AUTOMATIC TRANSMISSION SERVICE GROUP

"VOLUME II"

Since the introduction of the THM 440-T4 (4T60) Transaxle in April, 1984, there have been MANY major engineering design changes. These changes have affected nearly every part used in the THM 440-T4 (4T60).

This version, "VOLUME II", of the 440-T4 "Update Handbook" begins with the engineering design changes that occurred in the 1990 model year and will explain each change, the parts affected by the change, any parts interchange problems created by the change, and will be revised as necessary.

Figure 1

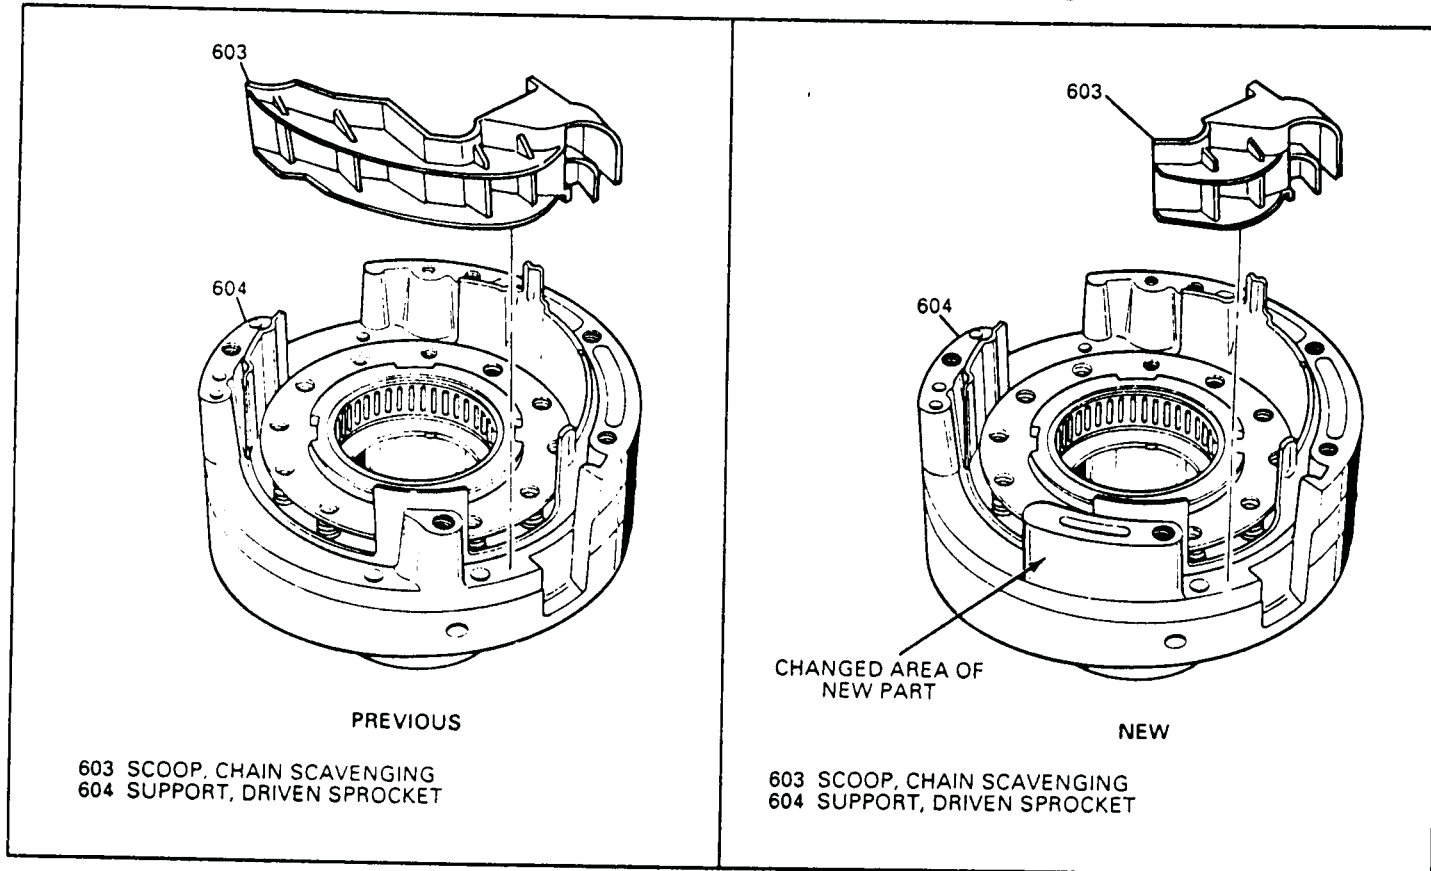
CHANGE: A new Driven Sprocket Support and Chain Scoop is now used in production on all 1990 vehicles equipped with a THM 440-T4 (4T60) transaxle. (See Figure 1).

- (1) **DRIVEN SPROCKET SUPPORT** - The new design sprocket support has an increased width of one leg on the support (See Figure 1). The wider leg on the new support will accomodate a new lube feed passage for the new THM F-31 (4T60-E) transaxle. Lube feed for the THM F-31 (4T60-E) will be thru the channel plate, instead of the pipe from the accumulator cover as on the THM 440-T4 (4T60) (See Figure 2).
- (2) **CHAIN SCOOP** - The new sprocket support requires the chain scoop, both black and white, to be about 1/3 the length of the previous chain scoop. (See Figure 1).

The new driven sprocket support will service all past models, but the new length (Short) chain scoop must be used with it. The previous (Long) chain scoop will not fit, but can be cut to fit the new support. Lay the previous chain scoop on the actual size drawing in Figure 3 and cut straight down, as indicated, with a hack saw. Smooth off the rough cut edge with sandpaper. The new length (Short) chain scoop must be used ONLY with the new design driven sprocket support.

Figure 4

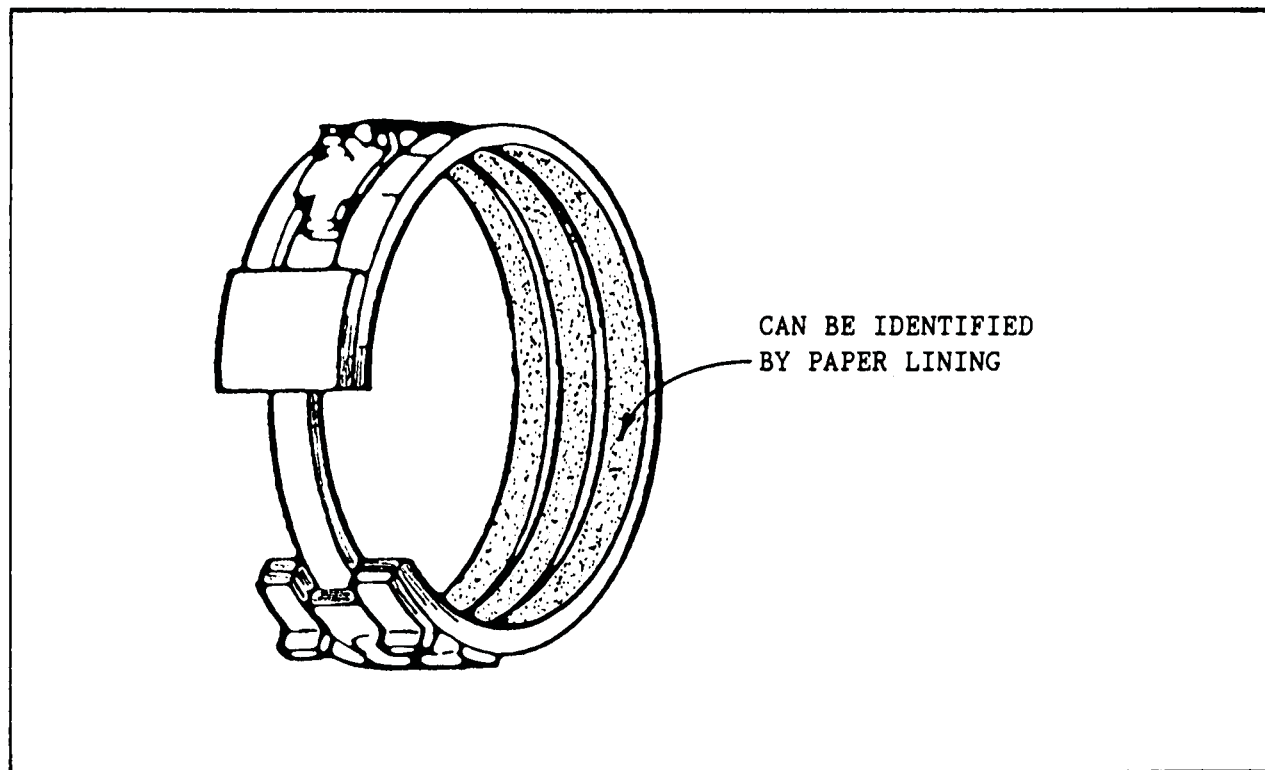
CHANGE: A 4th design Reverse Band Assembly is now in production on all THM 440-T4 transaxles.

- (1) REVERSE BAND ASSEMBLY - The lining on the reverse band has once again been changed, and can be identified by the "Paper" lining on the band itself (See Figure 4).

It will retro-fit back to all previous models and is highly recommended, to help eliminate a harsh reverse apply condition.

Figure 5

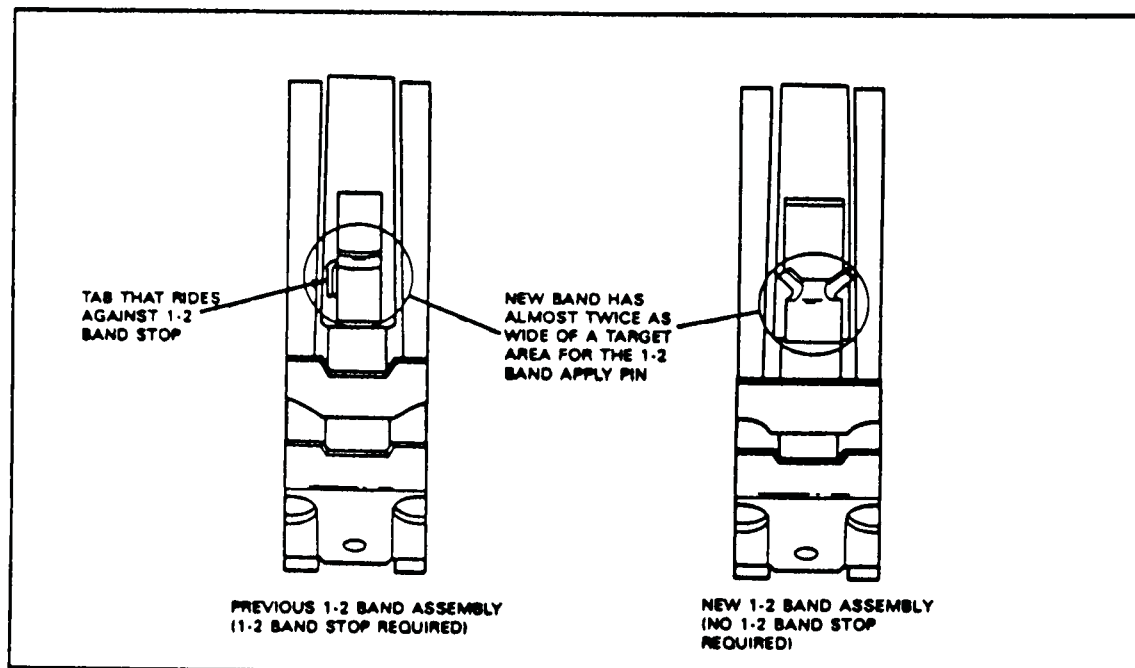
CHANGE: A new style 1-2 Band Assembly (See Figure 26) went into production beginning on January 16, 1990 (Julian Date 016) in all THM 440-T4 transaxles.

- (1) 1-2 BAND ASSEMBLY - The target area on the new 1-2 band, where the band apply pin engages, has been made wider and has "Wings" added to prevent the pin from ever missing the "Target" area (See Figure 5).
- (2) 1-2 BAND STOP ASSEMBLY - The 1-2 Band Stop has been eliminated as it is no longer needed (See Figure 6).

The new style 1-2 Band Assembly can be used to service ALL past models, but the 1-2 Band Stop MUST be removed and discarded (See Figure 6).

Figure 8

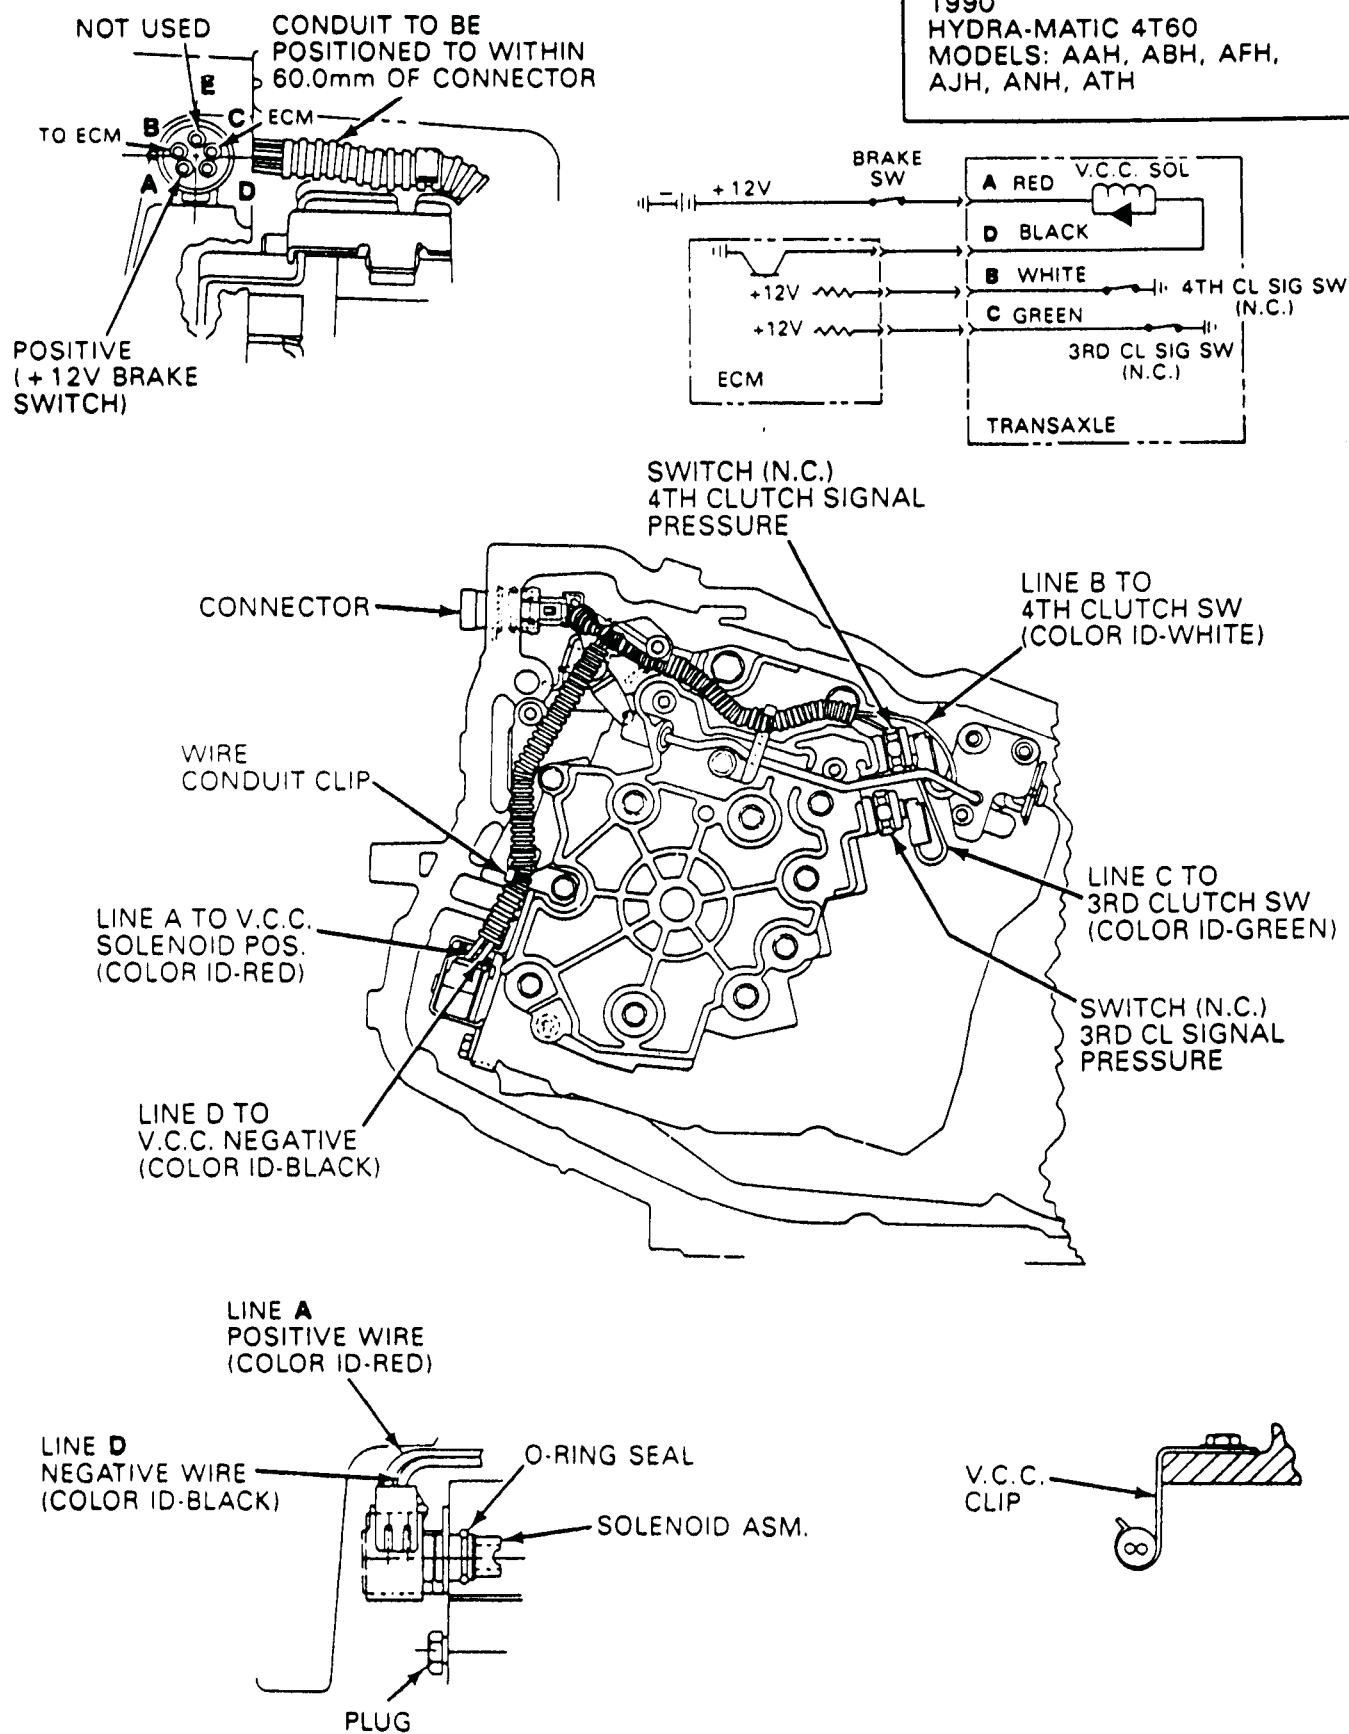
- (1) **PRESSURE SWITCHES** - The new 2nd, 3rd, and 4th clutch pressure switches will have "Button" head wire connectors instead of the "Blade" type connectors (See Figure 7).
- (2) **WIRING HARNESS** - The new wiring harness will have different type connectors to accommodate the new "Button" head switches. Refer to Figures 8, 9, & 10 for wiring harnesses.

Will retro-fit back to previous models, but both the switches and the wiring harness must be replaced.

Figure 11

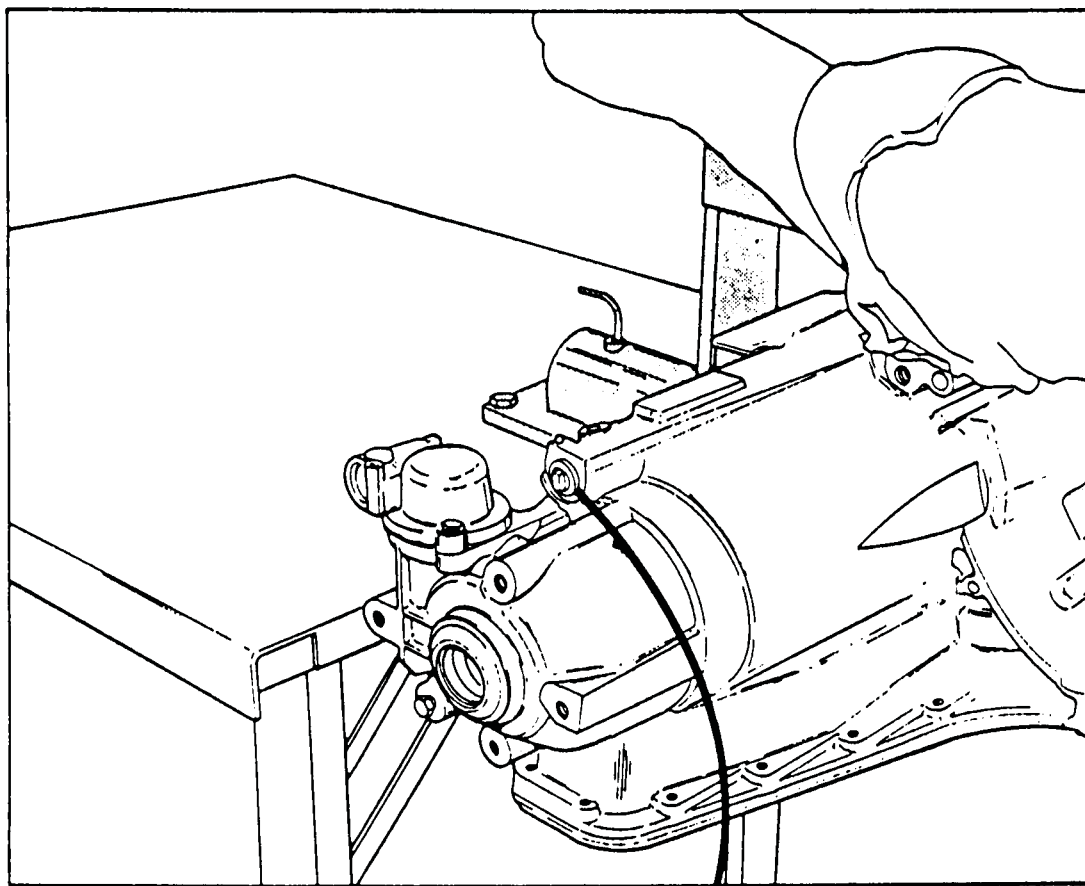
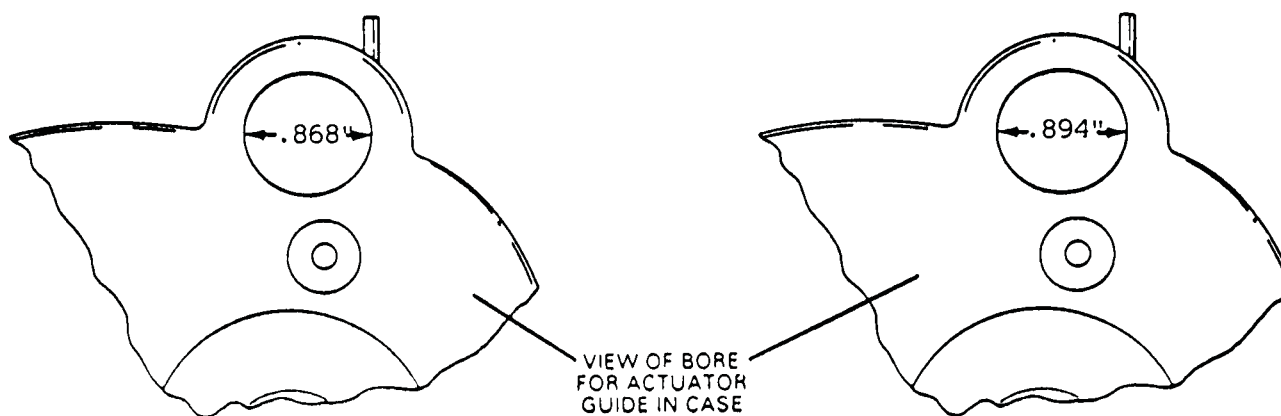
- (1) TRANSAXLE CASE - Bore diameter for the actuator guide has been increased by .026", to accomodate the new actuator guide (See Figure 11).
- (2) ACTUATOR GUIDE - Outside diameter has been increased by .026" for the increased diameter of the "Bullet" on the parking rod. The plunger assembly and spring have been eliminated. The slot in the actuator guide has been eliminated (See Figure 12).
- (3) ACTUATOR GUIDE "O" RING - The "O" ring is now larger diameter to seal larger diameter actuator guide (See Figure 12).
- (4) PARKING ACTUATOR ROD - The "Bullet" on the park rod is now .070" larger in diameter, and the length increased by .543" (See Figure 13).
- (5) PARKING PAWL - The parking pawl lock-out pin has been eliminated, and the dimension (Width) of the parking pawl was reduced by .039" (See Figure 14).

THE NEW PARK LOCK SYSTEM PARTS "CANNOT" BE USED TO SERVICE PAST MODELS UNLESS ALL THE COMPONENTS ARE REPLACED, INCLUDING THE TRANSAXLE CASE.

Figure 15

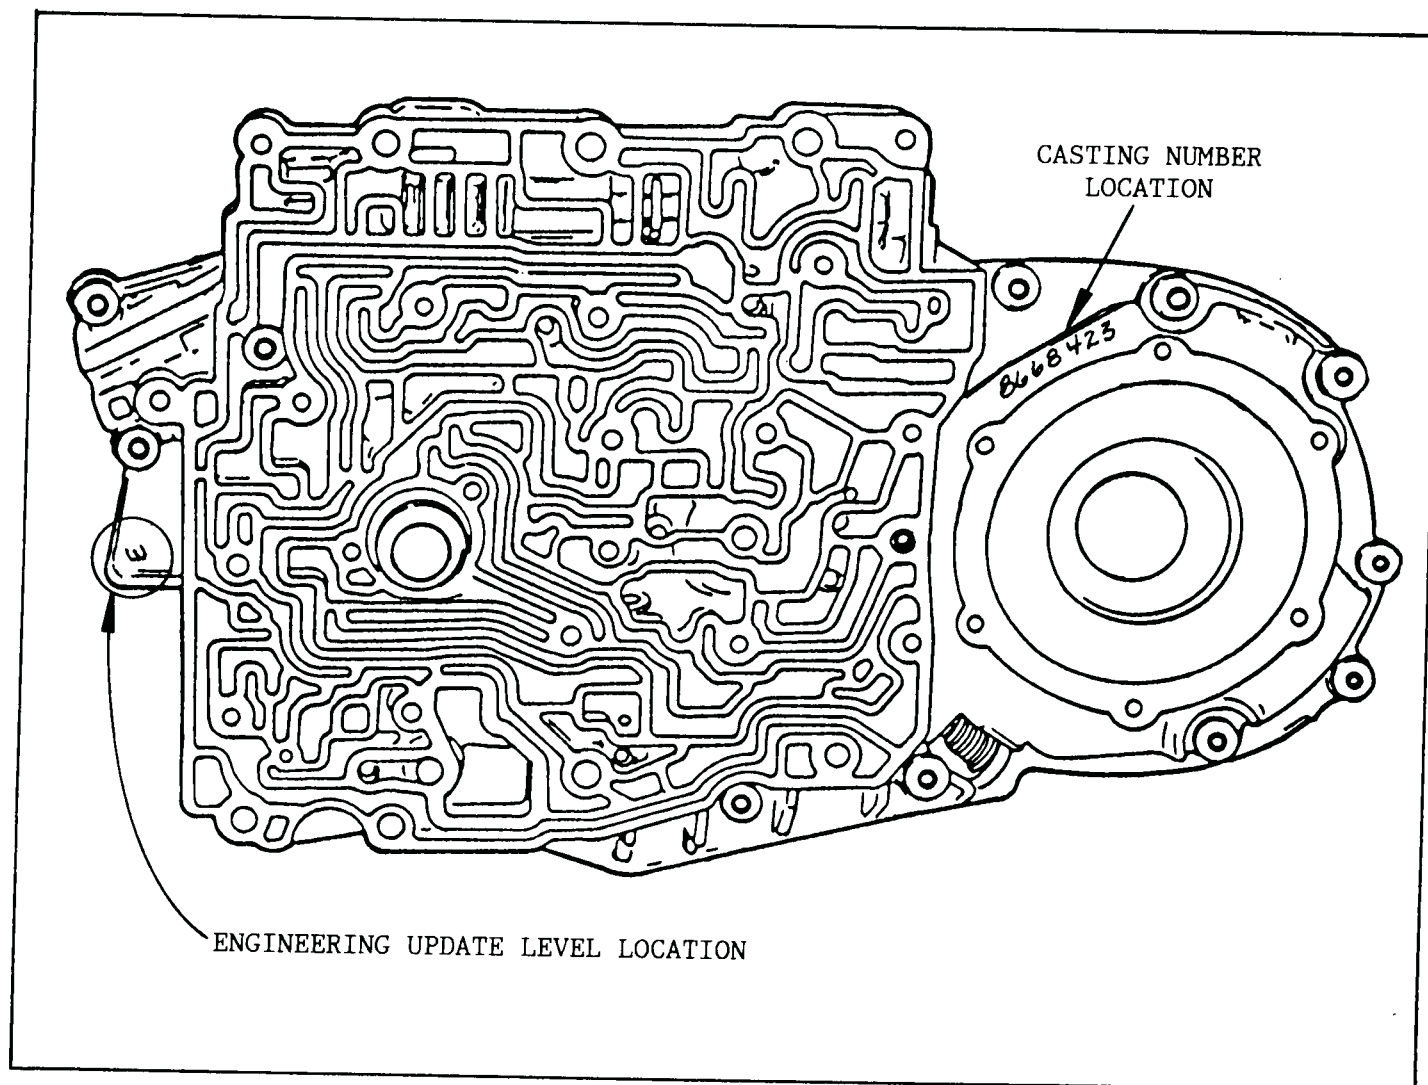
This was created by a change in the channel plate porting, in the manual valve area. The questionable channel plate can be identified by the casting number "8668423", with engineering update level "E". Refer to Figure 15 for locations. Casting number "8668423" with engineering update levels "A", "B", "C", and "D" are OK to use.

DO NOT USE CASTING NO. "8668423" WITH ENGINEERING UPDATE LEVEL OF "E" OR HIGHER - REFER TO FIGURE 15 FOR LOCATIONS.

CORRECTION: Install an earlier model channel plate that does not have the questionable casting number 8668423.

Figure 16

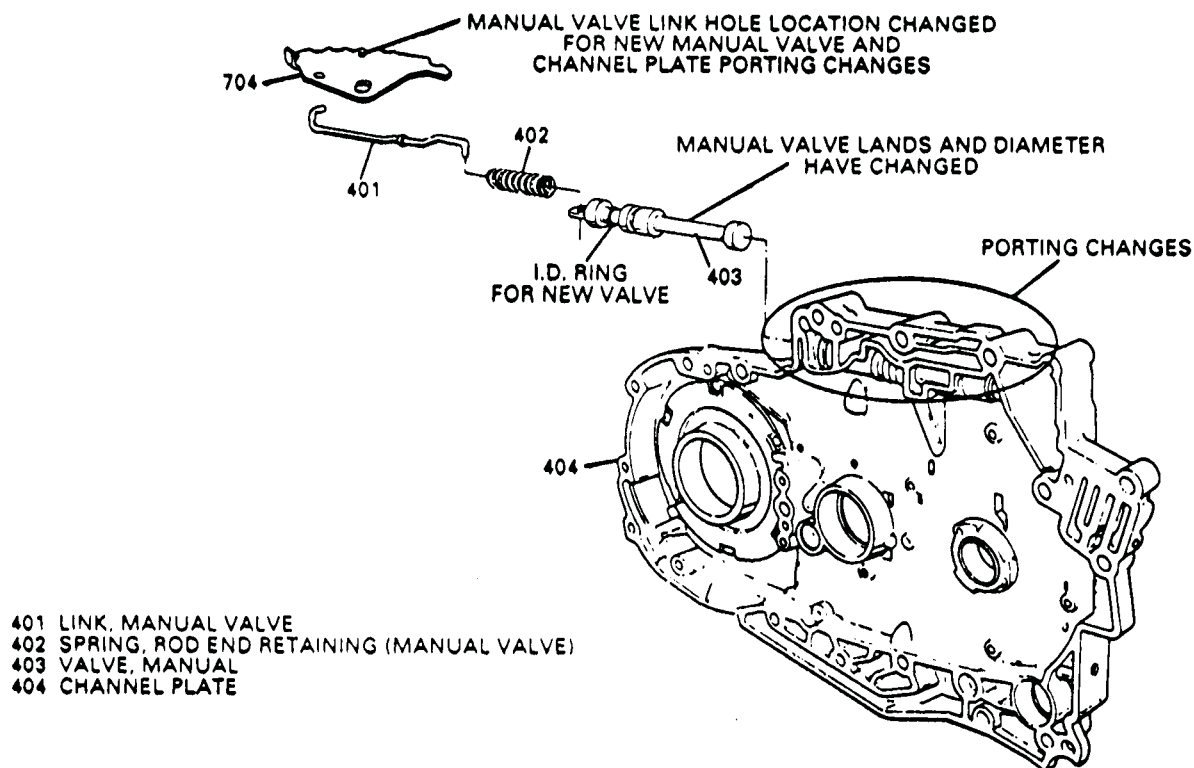
NEW CHANNEL PLATE - Will have porting changes for the new manual valve and new inside detent lever. The porting changes will help ensure that two ports will never be opened at once to cause burnt 4th clutch assembly. The bore for the new manual valve has been reduced by .010" to accommodate the new manual valve. This will make the previous and new parts non-interchangeable (See Figure 16).

Figure 17

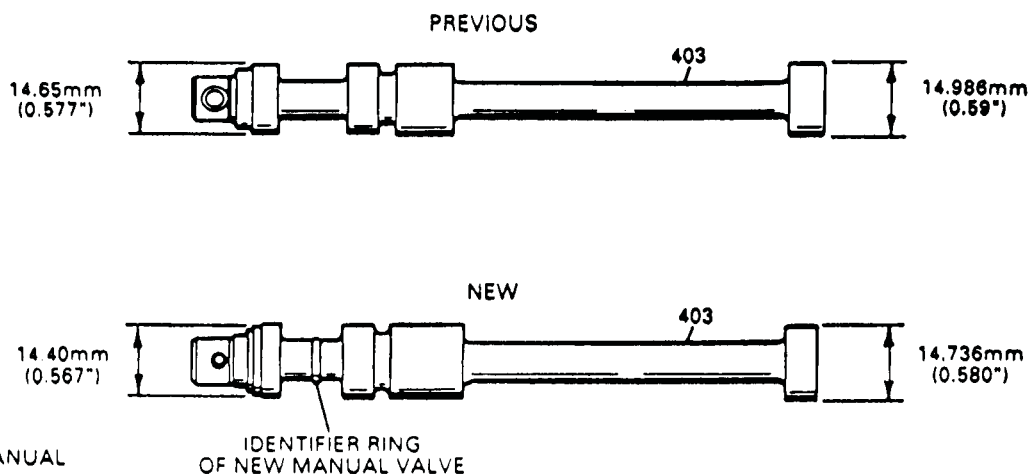
NEW MANUAL VALVE - Will have changes to the valve lands and reduced .010" in diameter to make it compatible with the new channel plate. The previous and new manual valve are not interchangeable. The new manual valve can be identified by a ring between the first two lands as shown in Figure 17.
